HISTORIC AND DESIGN REVIEW COMMISSION

October 19, 2022

HDRC CASE NO: 2022-520
ADDRESS: 424 CLUB DR
LEGAL DESCRIPTION: NCB 7013 BLK LOT W 60 FT OF 4
ZONING: RM-4, H
CITY COUNCIL DIST.: 7
DISTRICT: Monticello Park Historic District
APPLICANT: Mark Ramirez
OWNER: TRIO INVESTMENT PARTNERS LLC
TYPE OF WORK: window replacement and fenestration changes, construction of a rear two-story deck
APPLICATION RECEIVED: September 23, 2022
60-DAY REVIEW: Not applicable due to City Council Emergency Orders
CASE MANAGER: Jessica Anderson
REQUEST:

AN ADDITION AT
424 CLUB DR.
MONTICELLO PARK
SAN ANTONIO, TX

These drawings are incomplete and may not be used for regulatory approval, permit or construction. For review only.

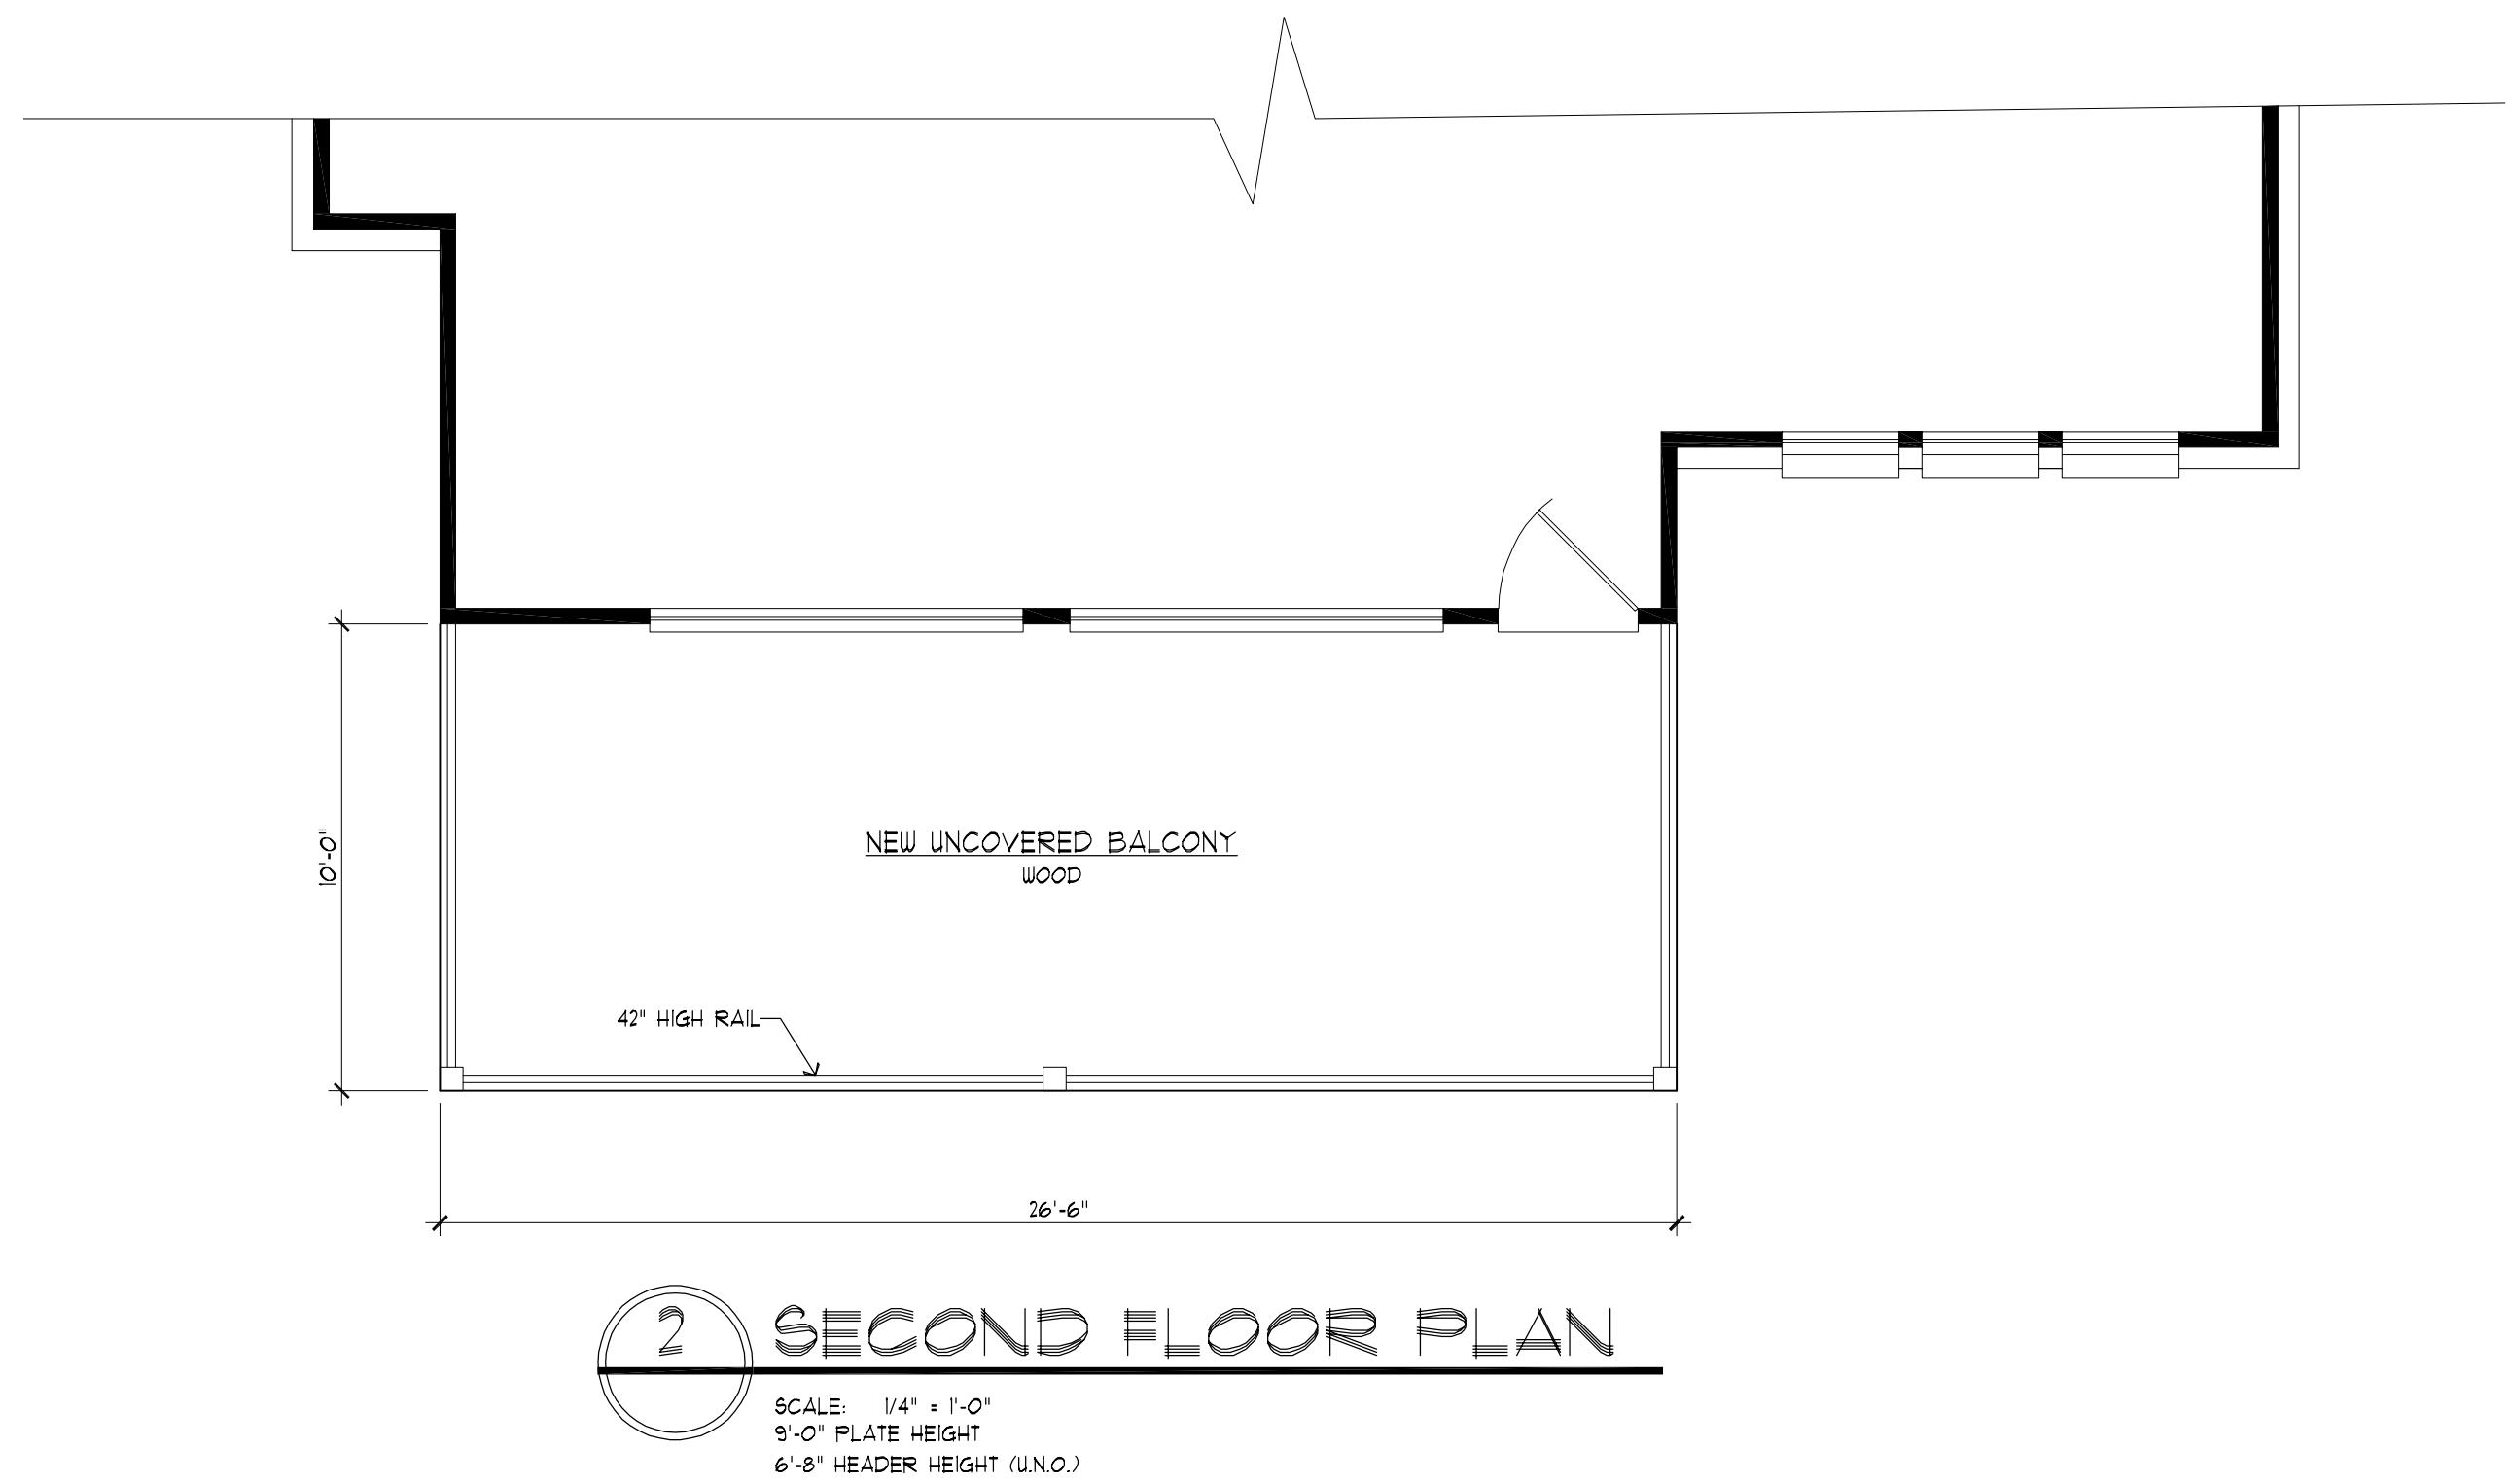
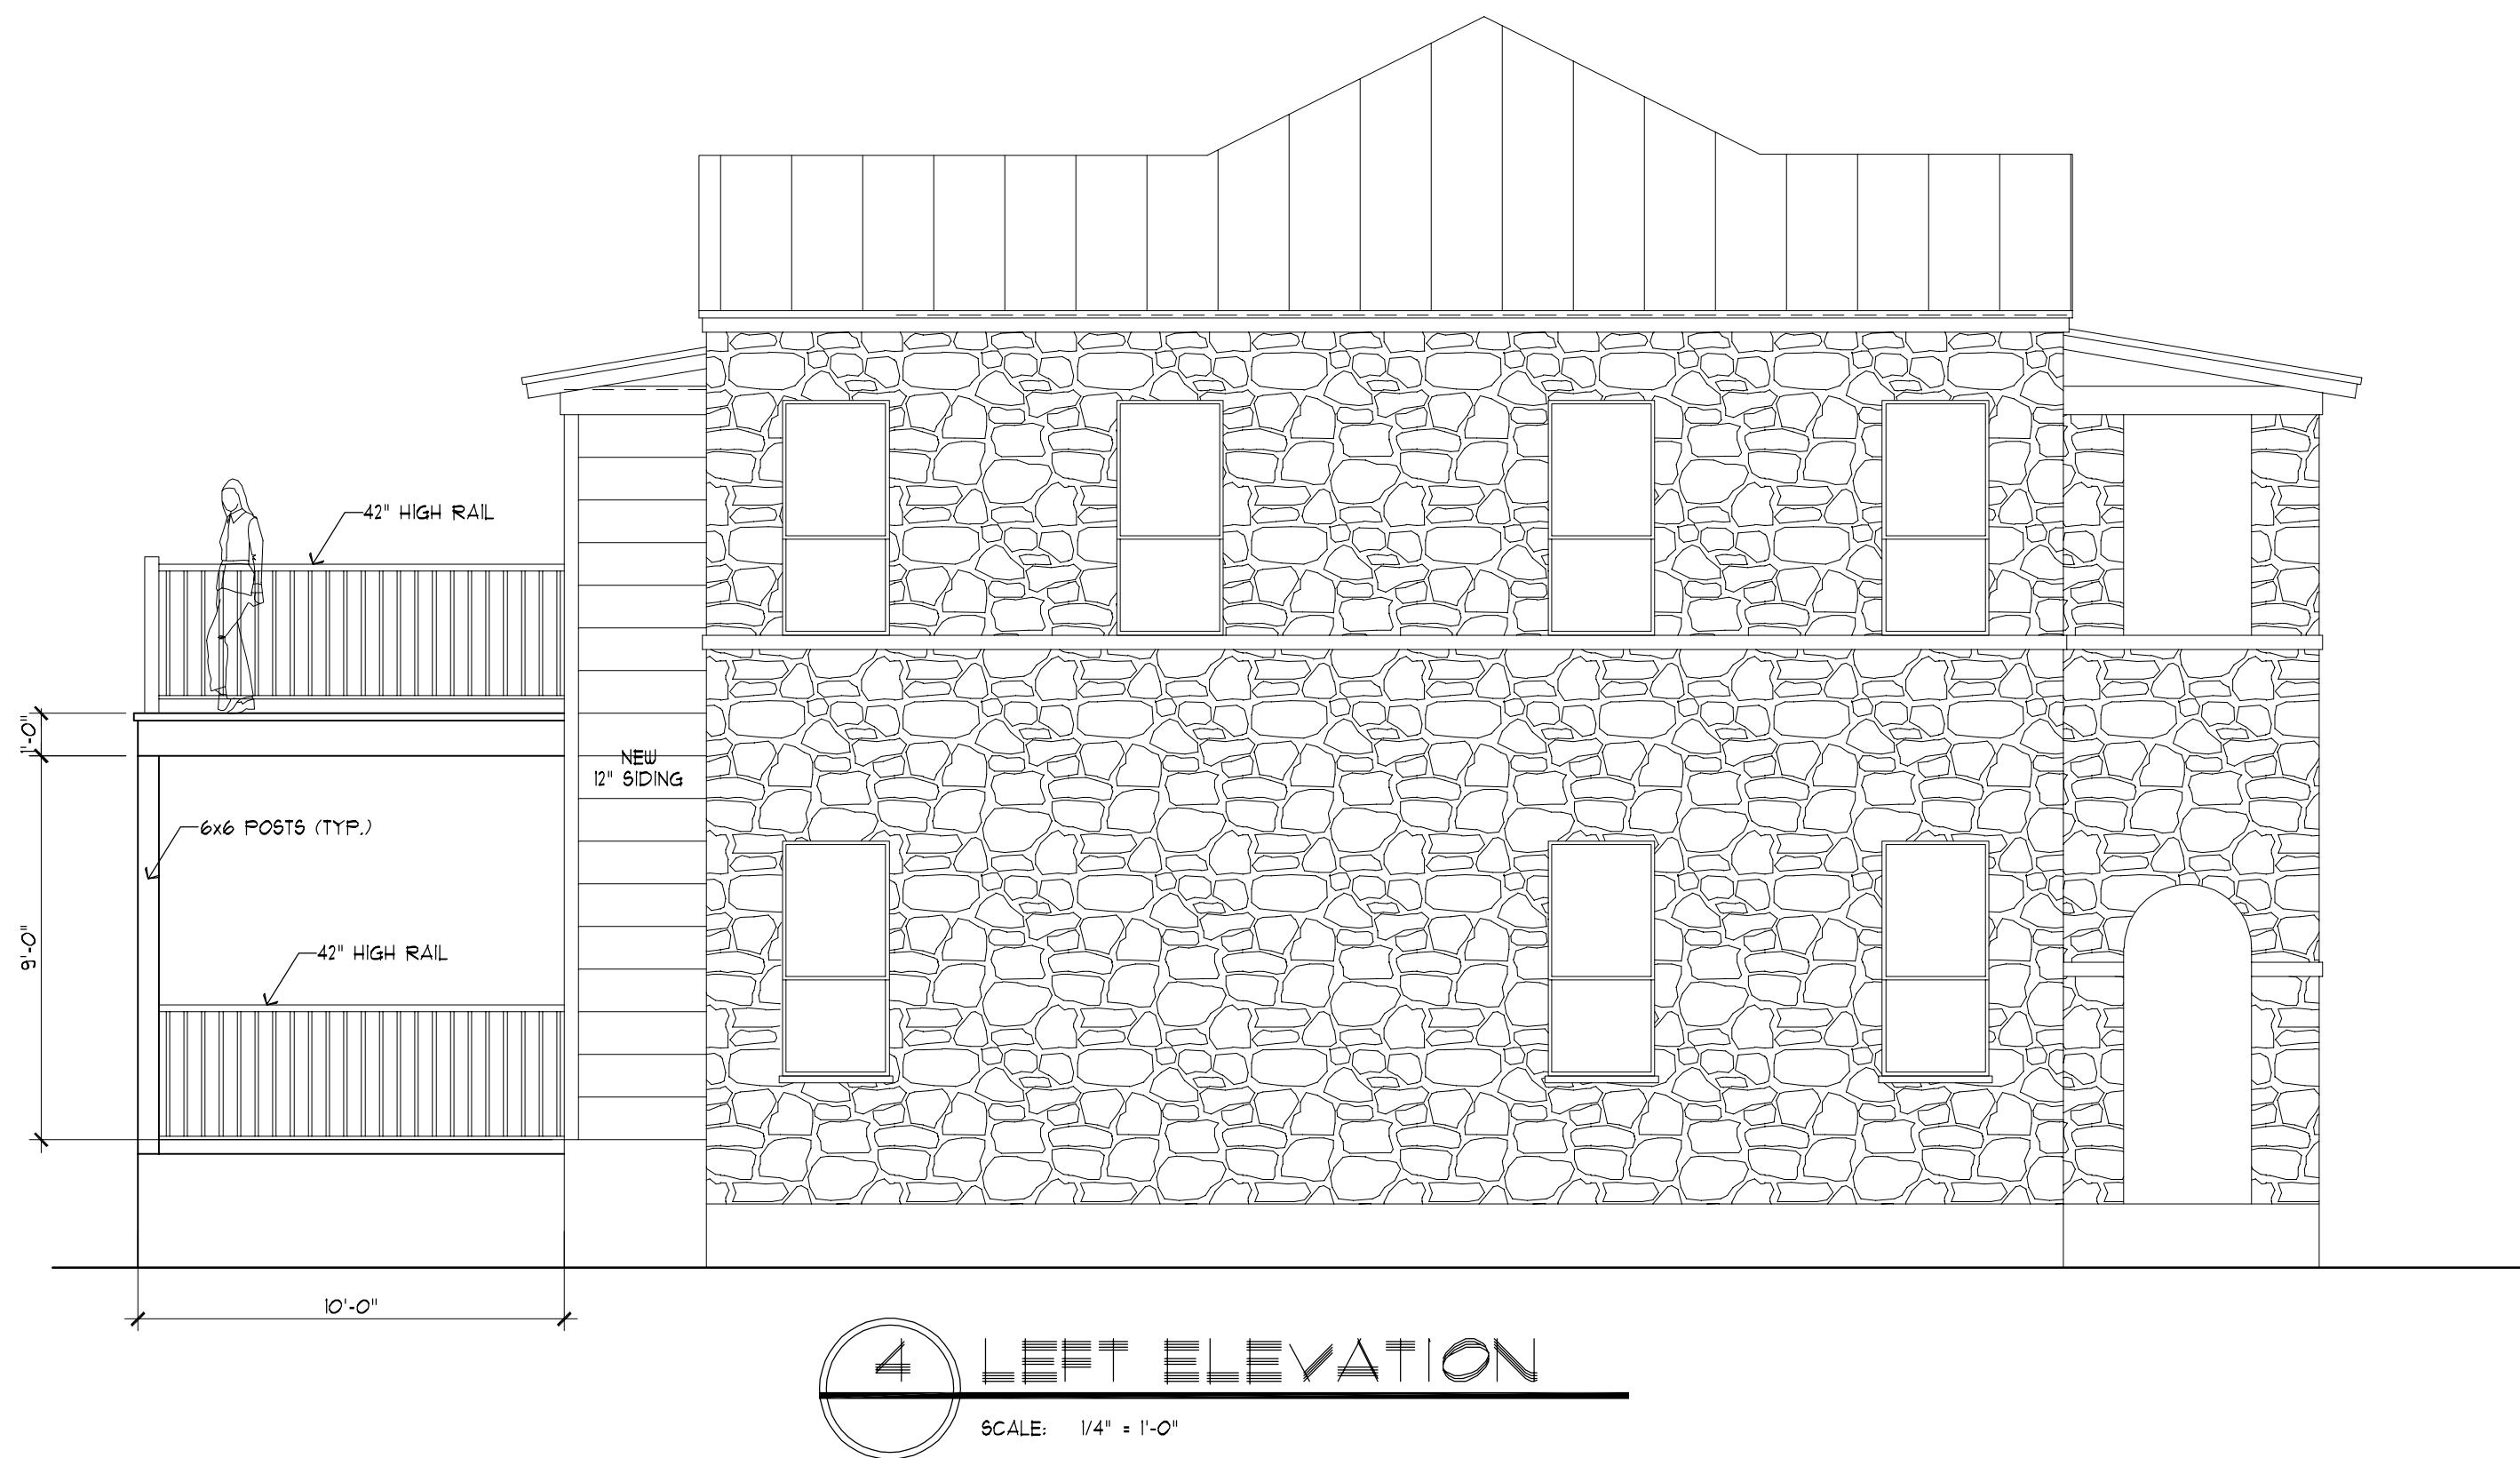
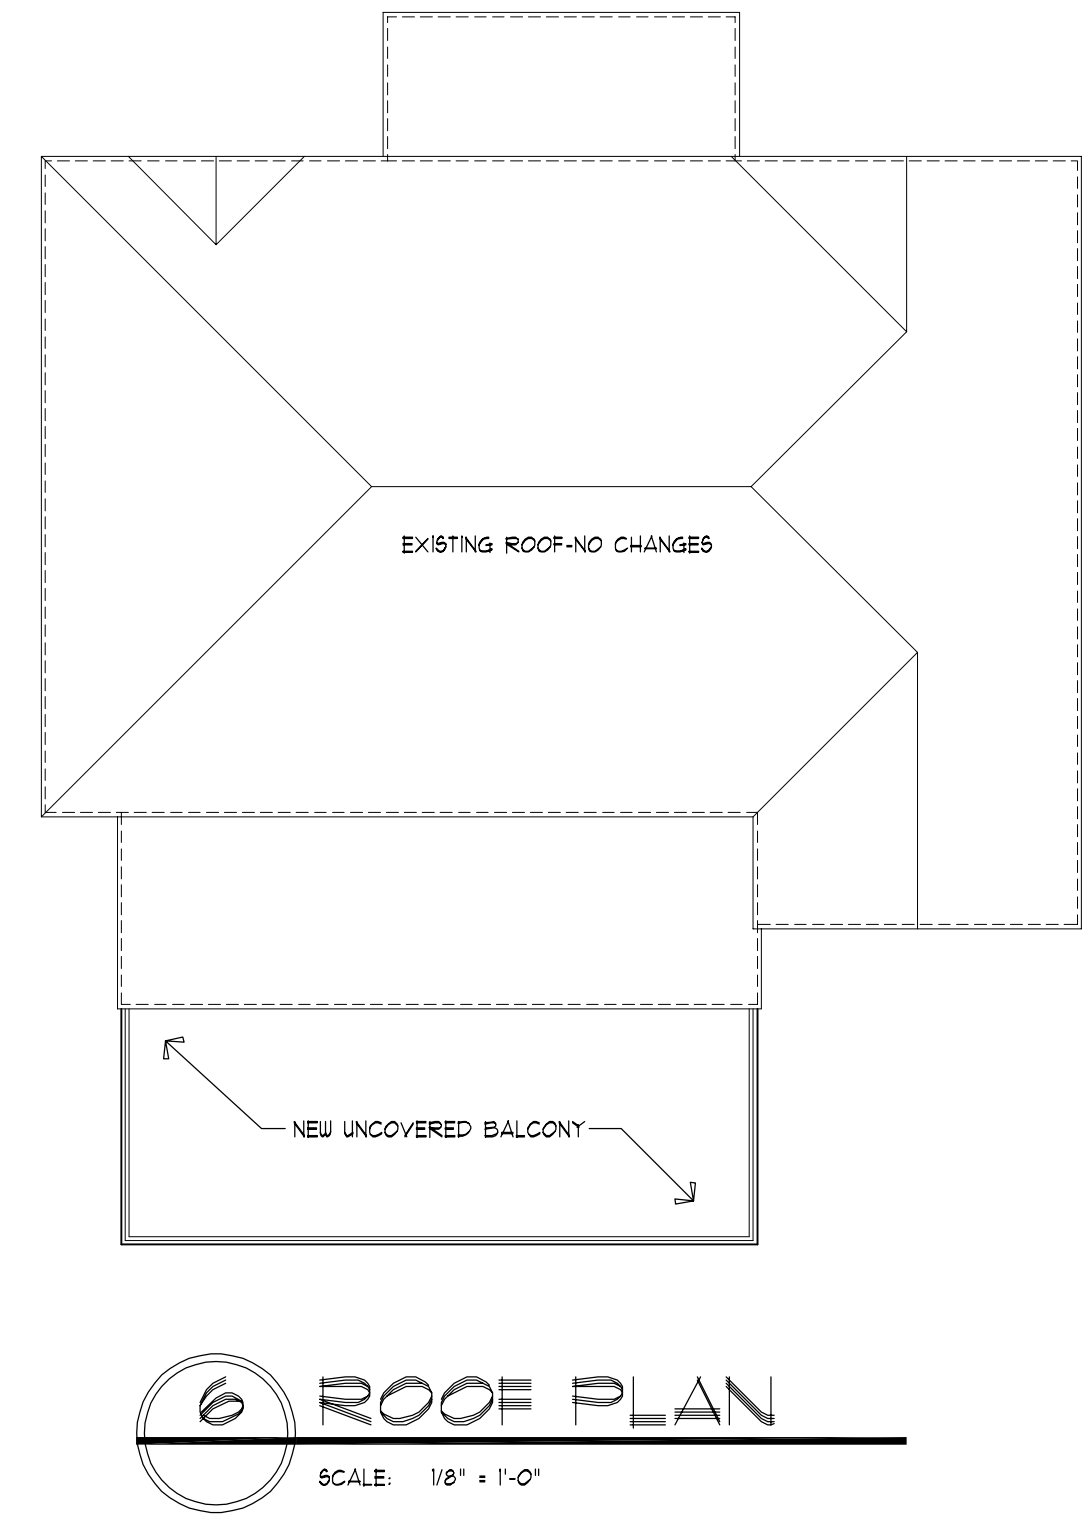
- e. **ADDITION: REAR PORCH:** The applicant requests approval to construct a two-story rear porch and to restore a door at the east end of the second floor of existing enclosed porch. Historic Design Guidelines for Exterior Maintenance and Alterations 7.B.v states that porches, balconies, and porte-cocheres should be reconstructed based on accurate evidence of the original, such as photographs. If no such evidence exists, the design should be based on the architectural style of the building and historic patterns. Staff finds the porch conforms to guidelines and that returning the second-floor door is appropriate. The applicant must ensure the new porch conforms to all setback guidelines as defined by UDC.

- f. **FENESTRATION CHANGES:** The applicant requests approval to remove one door from the primary elevation and replace it with a one-over-one window. Historic Design Guidelines for Exterior Maintenance and Alterations 6.A.i and ii state that historic doors and windows should be preserved. Staff finds the proposed door removal does not conform to guidelines.

Staff recommends approval of item 3, construction of a two-story rear porch and return of the rear second-floor door, based on finding e, with the following stipulation:

- i. That the applicant meet all setback requires as defined by UDC.

Staff does not recommend approval of item 4, replacement of one front door with a window, based on finding f.
